NRPA Application – boat ramp/dock repair project

Attachment 1: Activity Description

Attachment 2: Alternative Analysis

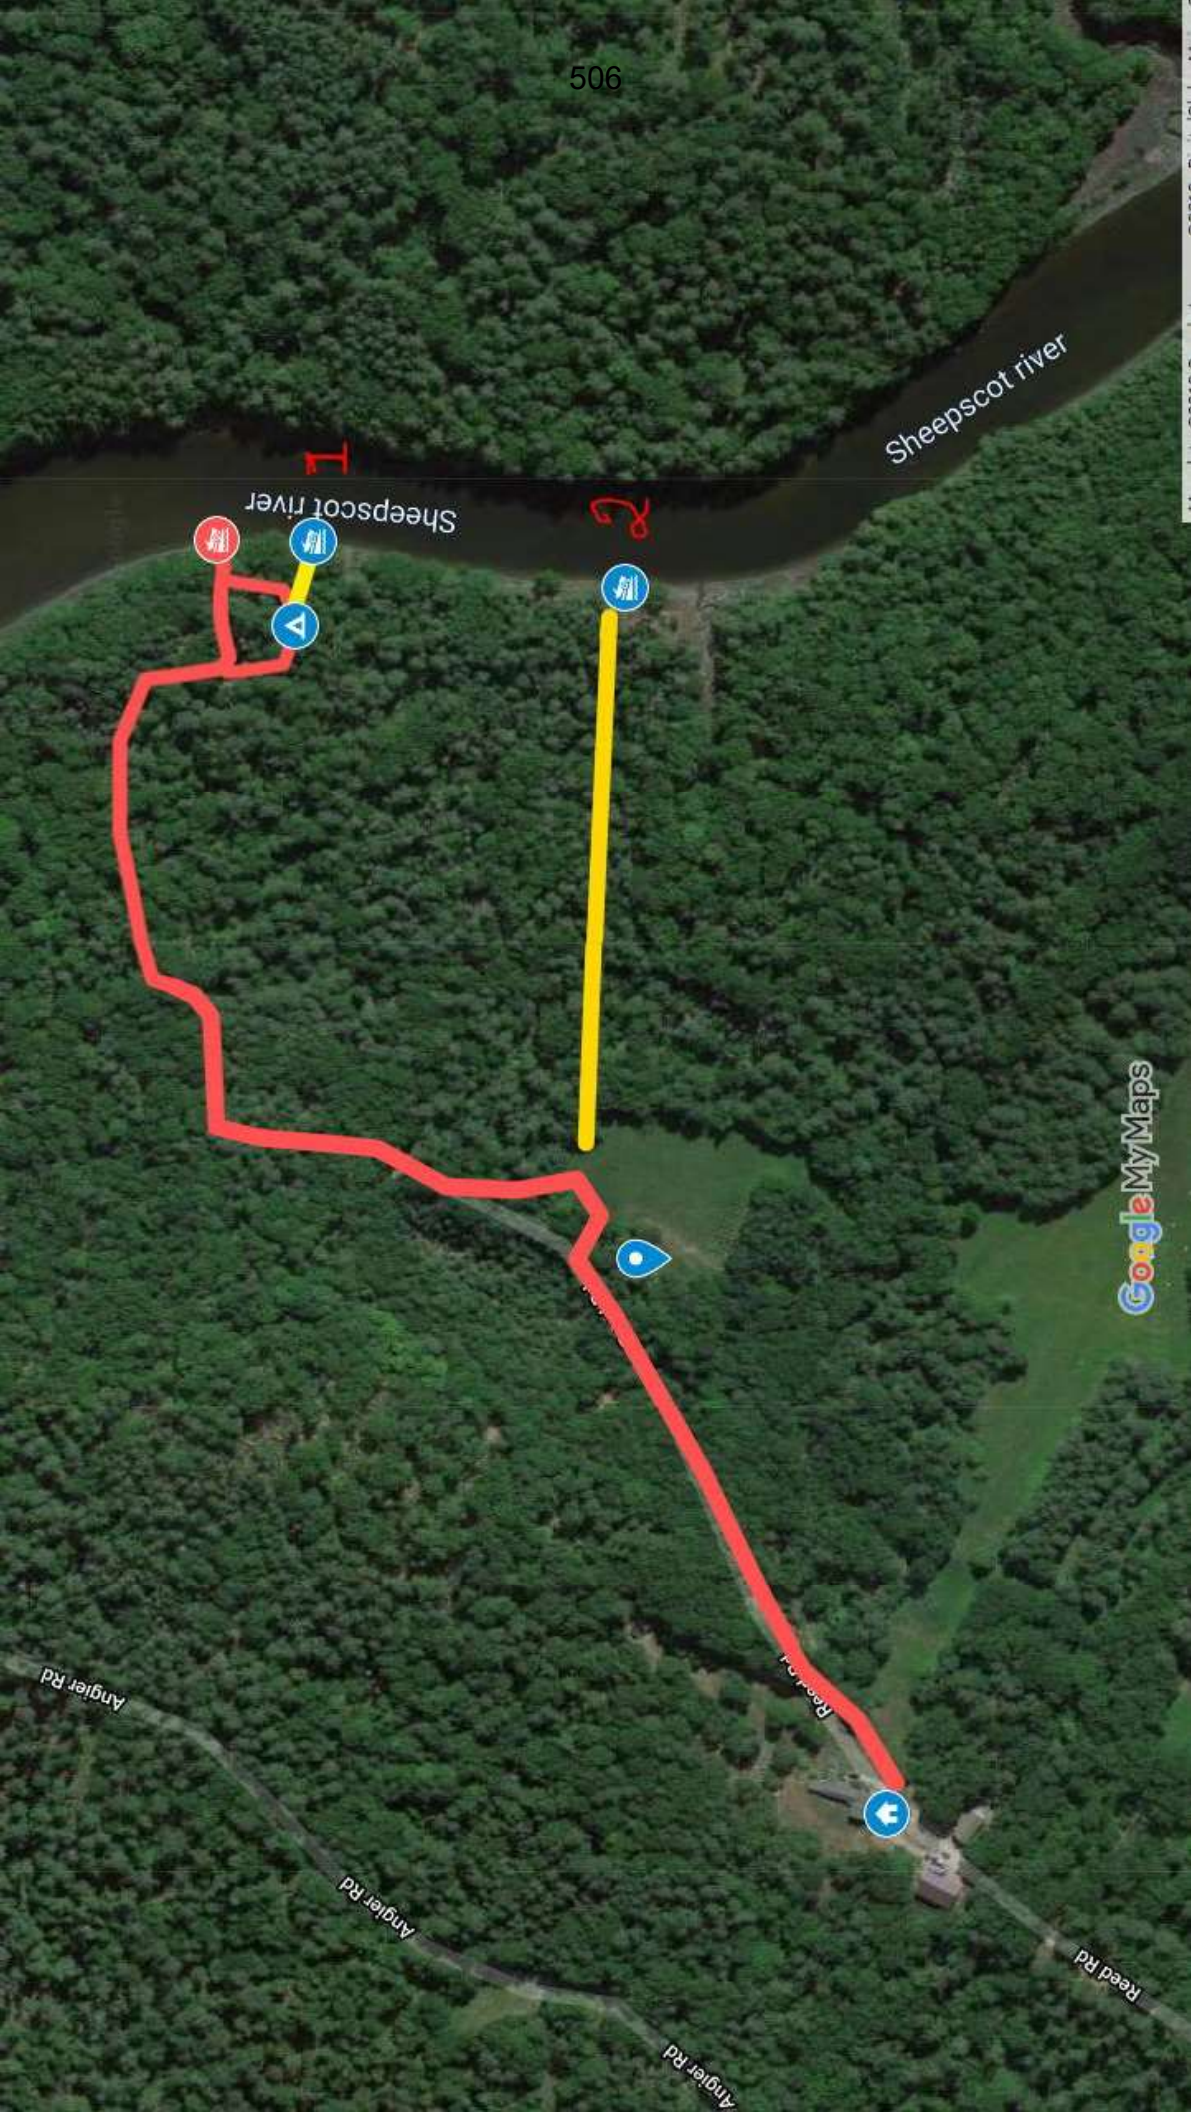
Alternate site locations: The far Southern portion of property (just off photo bottom) is salt marsh and unsuitable for use. The area from bottom of photo to just south of option 2 is steep/rocky incline and therefore unsuitable for use without significant alteration.

Option 2 would require the construction of a new road from the small field or the camping area approximately 800-1000' long for access (large yellow line), as well as an new embankment cut. The shoreline is also steeper at this location as it was used to load brick barges in past and has a sharp drop off.

Option 1 would require a small (100-150' road from camping area – small yellow line) and could pose a reasonable alternative location, although it would require removal of several trees and a new embankment cut in rivers shoreline.

It would seem that the relative tradeoff of impacts would indicate that the least impactful site solution is the proposed (and already in use) one (the top, red marker on above map) as 1.) the established road system already exists and would not need to be created either in terms of cost to the club or in terms of environmental impact, 2.) the river embankment already has an established cut as it is currently an in use ramp and 3.) minimal if any additional tree removal would be necessary to support construction.

River survey - docks, boats, sights

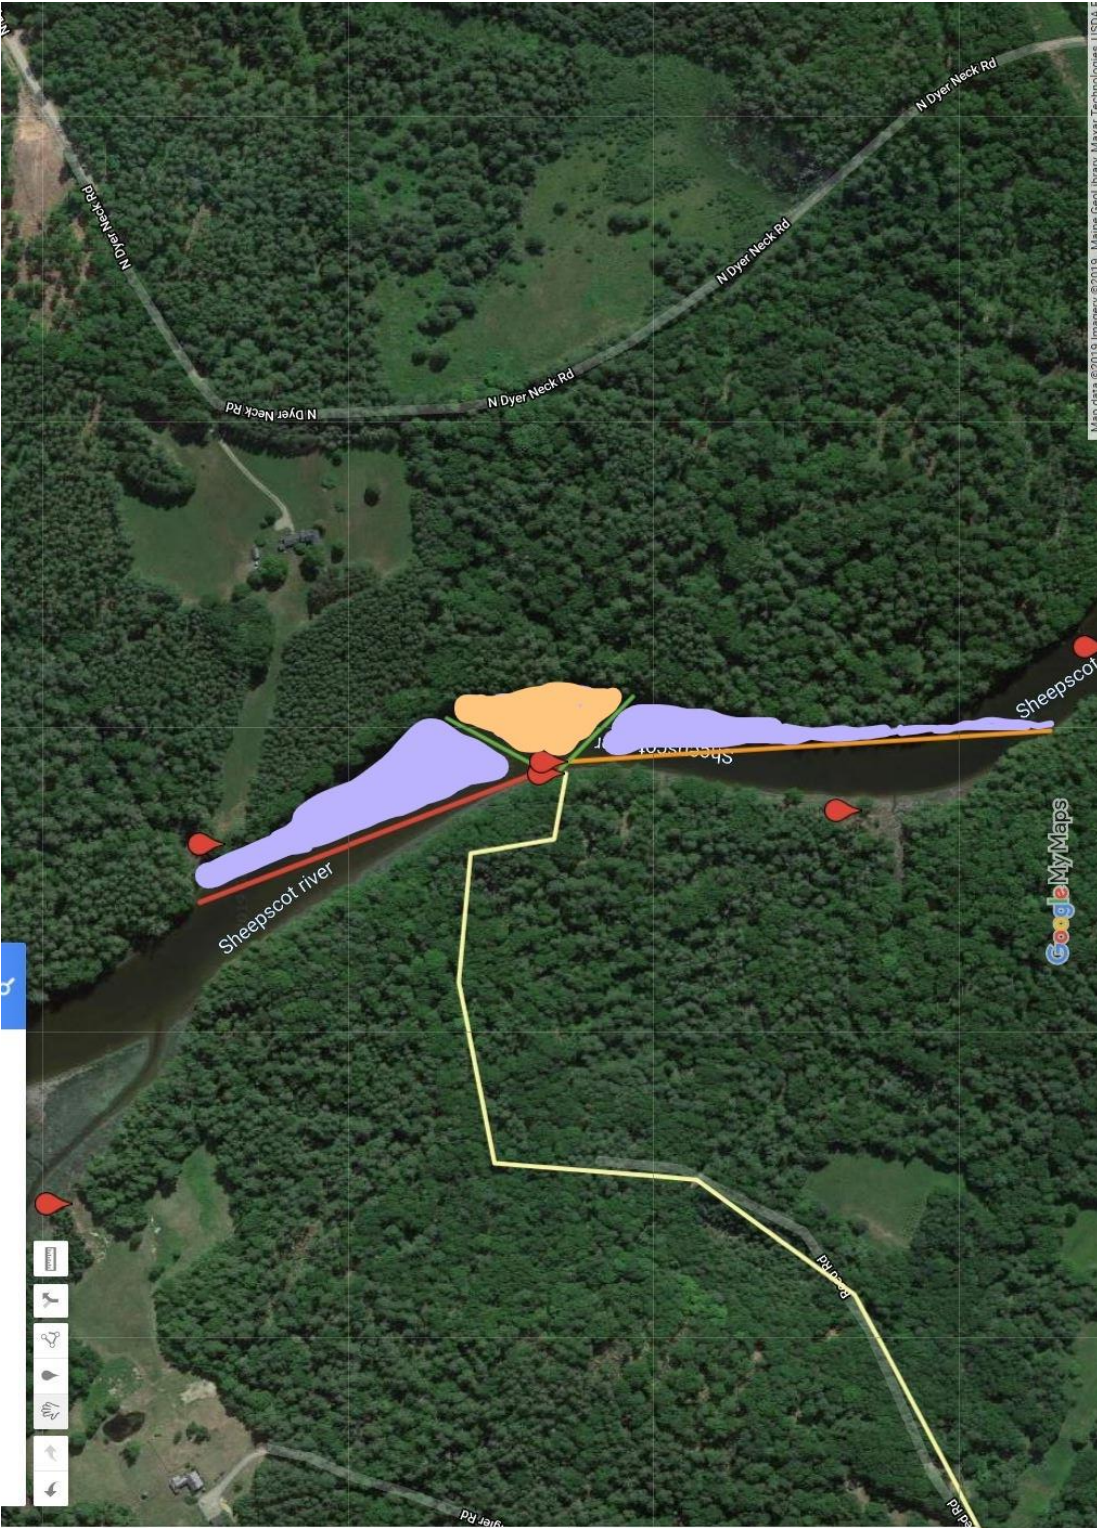
I have been trying to come up with a visual depiction to help handle the concept of visual dominance/line of site issues. I located an 18" mooring ball in my garage and anchored it 51' off the shoreline at the dock location (admittedly approx. 5' short in terms of projected extension but at least it's a visual reference point and i was by myself doing it so hard to get exact placement of the anchor/mooring.)

Measuring, i found that the mooring ball is approx. the same height as dock floating in water, and i used one of my jon boats to get some photographs as to 'when it comes into view' from north and south at approx. mid tide. Attached you will see a google map overlay with what i would call the lines of visibility (the purple & yellow areas are the areas where you can see the dock from.

As you can see, since the dock is just South of the 'apex' of the point of land (coming from north) that and the corner/grass extending just north of dock limits the sighting starting from near end of bill weary's field. (east side of river) to directly across from the dock location.

From the south, the dock's visibility is limited by the point of land just to the south (bill weary's land) and you can see the mooring ball (simulated dock) from an area along my land to east of orange line as river curves north around corner.

Purple area is lines of visibility for dock float extended out into water.

The green lines are what i estimate the boat ramp visibility to be based on the same boat trips and my photos. The ramp, assuming it is flush (or nearly flush) with natural surface as i intend to make it is hidden by the grass & embankment on both north and south sides as the land has a 'curve' to it. I estimate the area of visibility (for the ramp only) to be the triangle to the direct East side of ramp between green lines.

Yellow area is lines of visibility of boat ramp when flush or near flush to terrain as planned. Of course you can also see the dock in the yellow area too in addition to ramp.

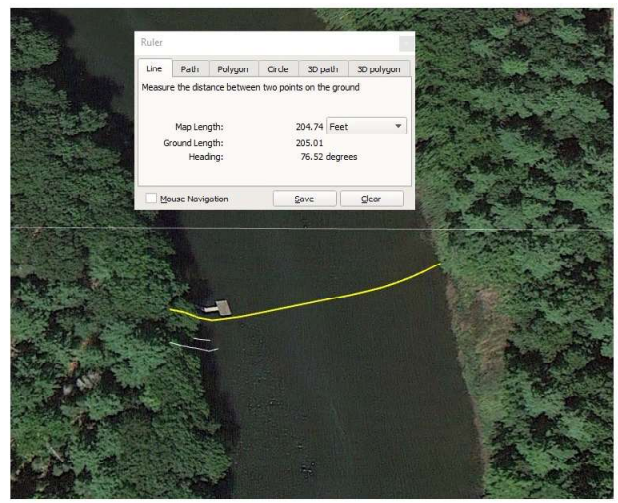
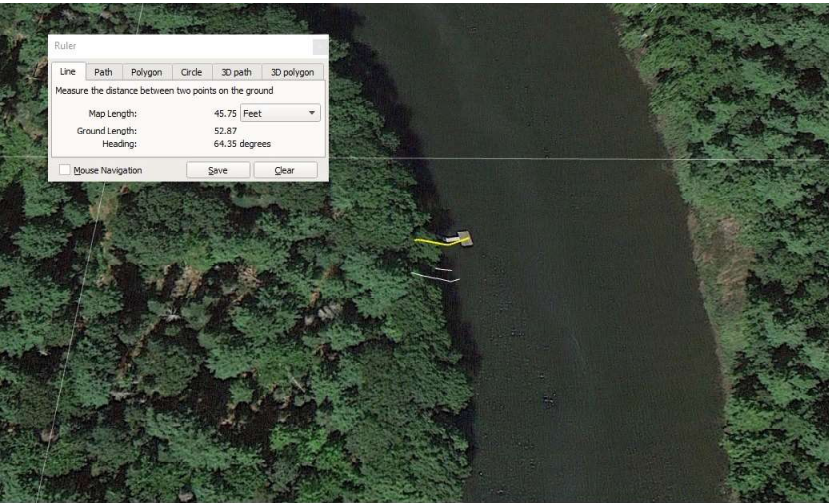
- Left photo measures dock system protrusion from shore. (~45' or so including pier/ramp/floats - trees shown hang out over river on left side which is deceiving in the picture)

- Right photo measures river width (approximately 205' from this particular measurement) as best i can and puts it into visual context with river.

I figured i would provide this graphic to help as some additional support that the dock even at the MAXIMUM POSSIBLE estimation of 35' (ramp) + 16' (max extension/runout float that supports ramp end) + 8' (float) = 59' (total) as i drew in my NRPA plan, will extend 29% into/across the river - approx. the width of the end float additional to the existing picture here)
